S.I.L. NO. 03-560-06

SERVICE INFORMATION LETTER

SUBJECT: Auto Ignition Pressure Switch Location

Figure 1

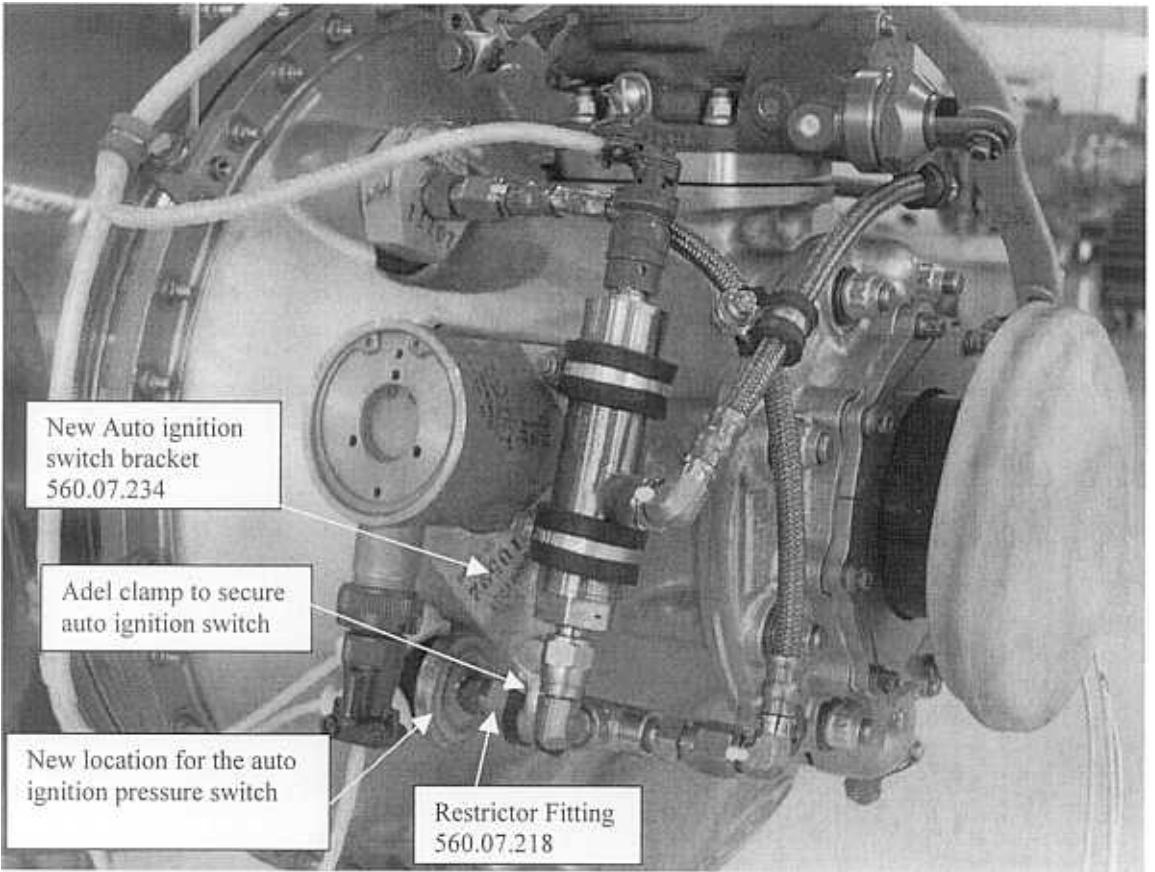
We recommend revising the configuration of the plumbing for the auto ignition pressure switch located of the forward right side of the engine. The new configuration is shown in Figure 1 below. This configuration should help isolate the pressure switch from vibration and result in a longer service life for the pressure switch. This new configuration does require a new bracket to help shock mount the pressure switch and an additional adel clamp and hardware.

- a. Remove the top cowling.
- b. Reconfigure the plumbing for the torque transducer and auto ignition pressure switch as shown in Figure 1.
- c. Use a little fuel lubricant (or equivalent) on the pipe fittings.
- d. Perform an engine run to ensure there are no leaks and that the auto ignition switch functions properly.
- e. Replace the top cowling.
- f. Make a log book entry stating that the auto ignition pressure switch was relocated in accordance with JetProp Service Information Letter 03-560-06.
